# Harvard Avenue - Proposed New Residential Construction Project (SDCI #3025137)

SEATTLE DESIGN REVIEW

July 19, 2017 | Recommendation Meeting

# GROUND FLOOR SERVICES

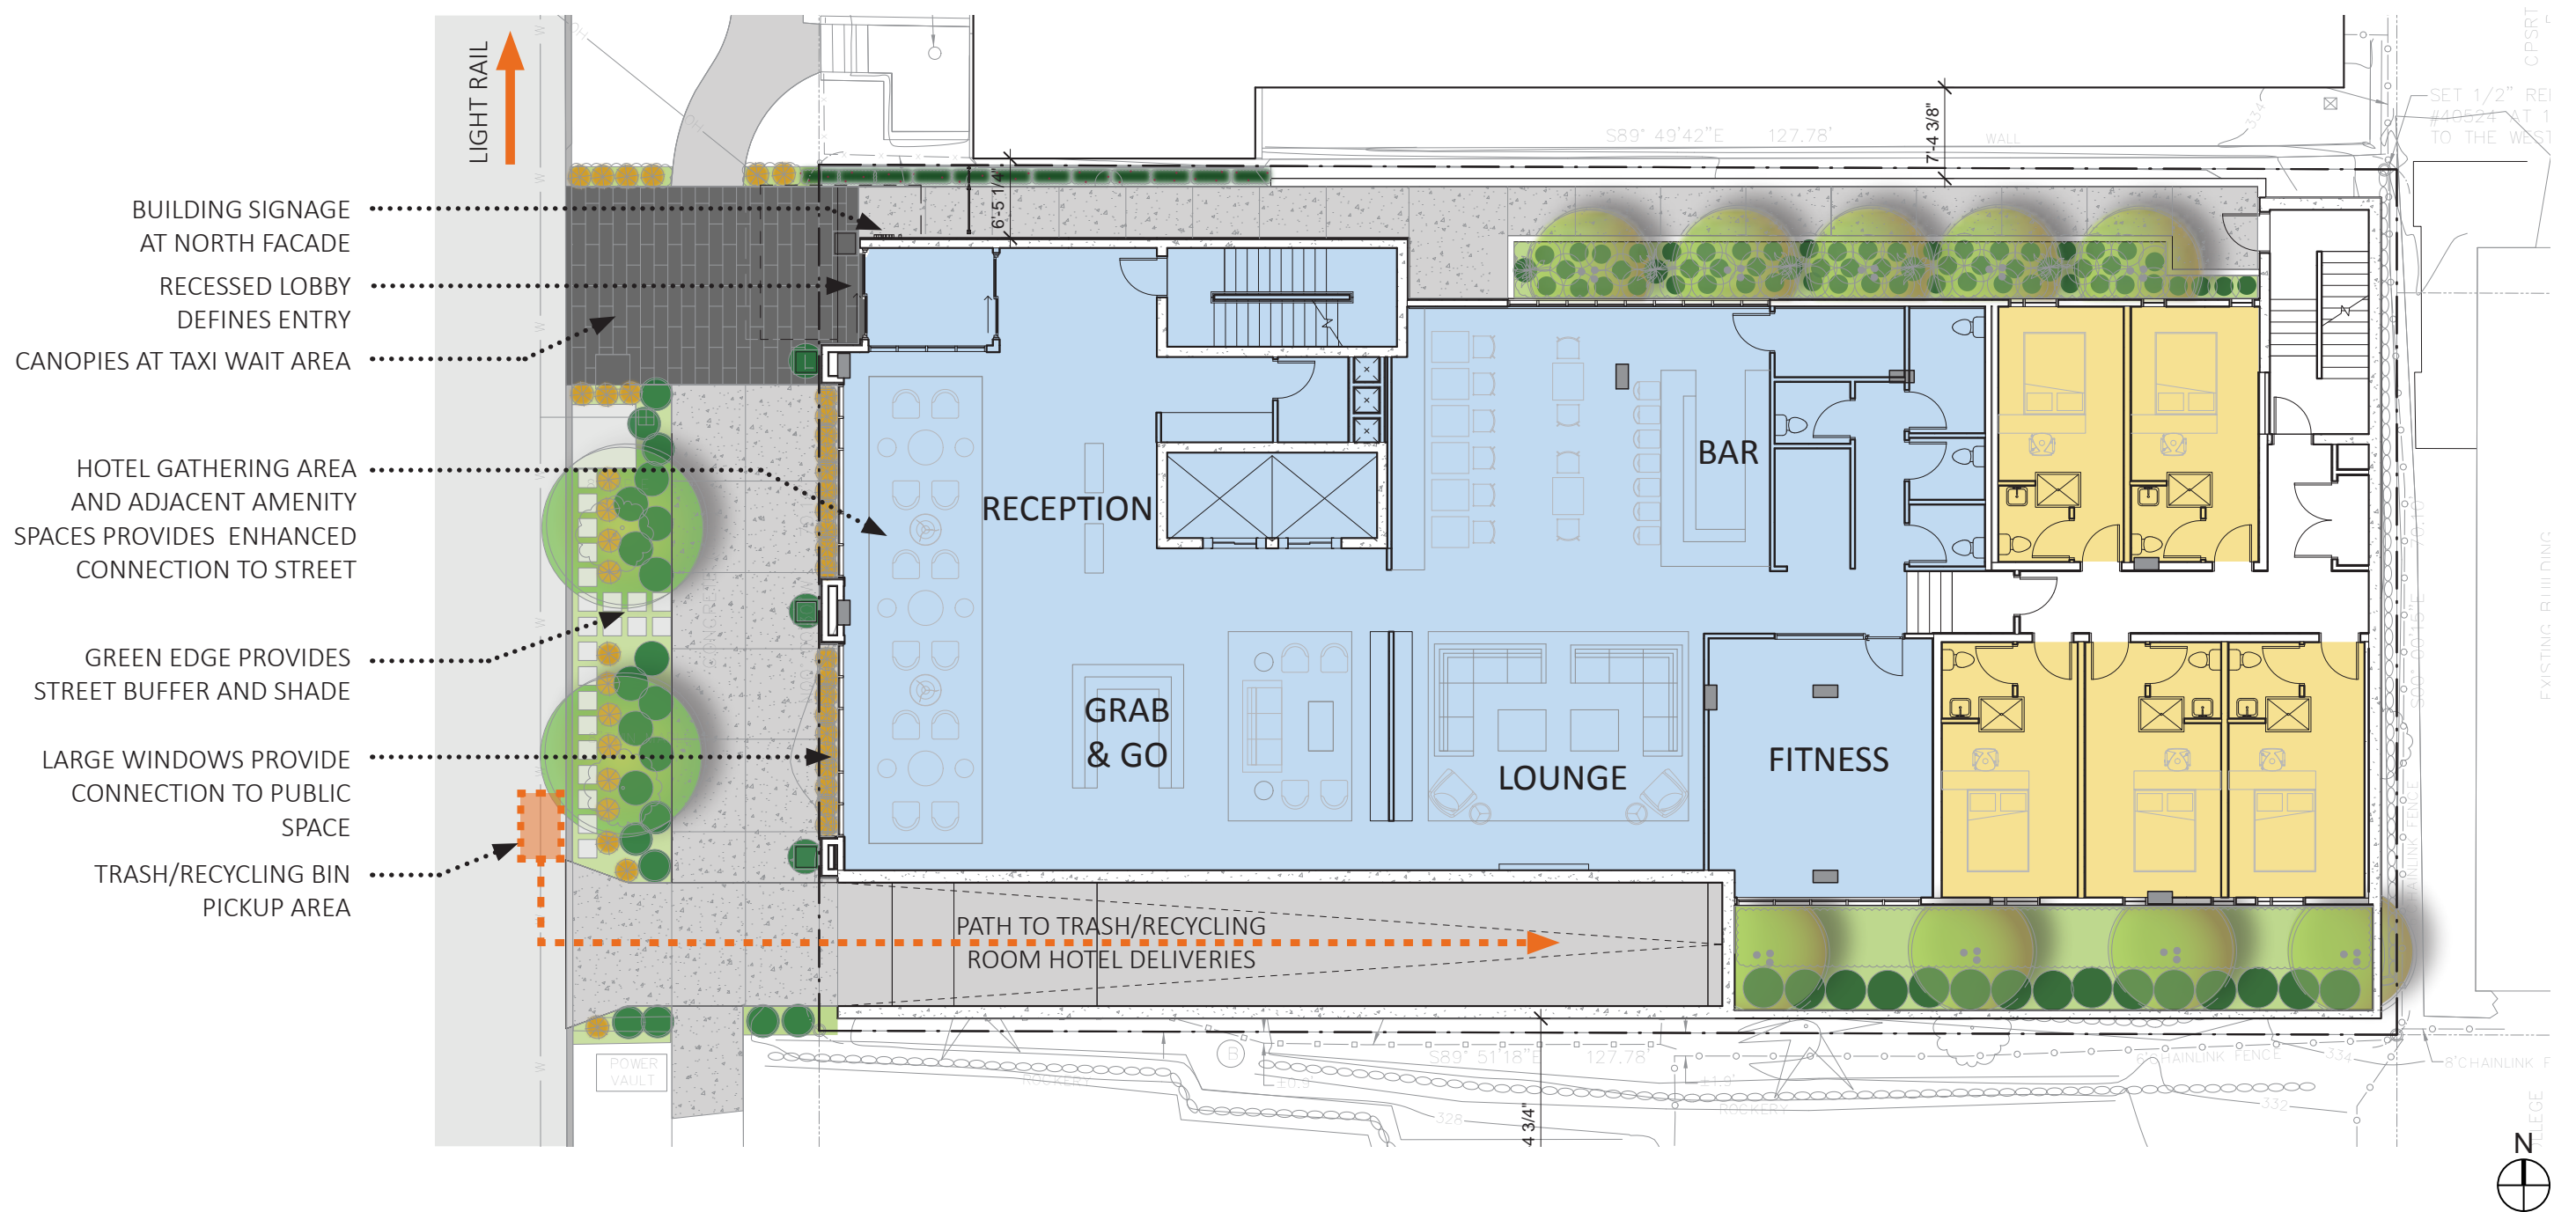
- The board requested a thorough illustration and analysis of trash service and the lobby/amenity area in the Recommendation Packet.
- The board supported a requested departure for reduced curb cut and drive aisle width to minimize the impact of the parking access on the lobby.

Trash from lobby/amenity area is removed to trash/recycling room on P1 level. Trash and Recycling bins will be moved up ramp to area at street adjacent to curb cut for pickup away from front entrance and primary pedestrian circulation. (CH DC1-I, DC1-C, DC1-A, PL3-A)
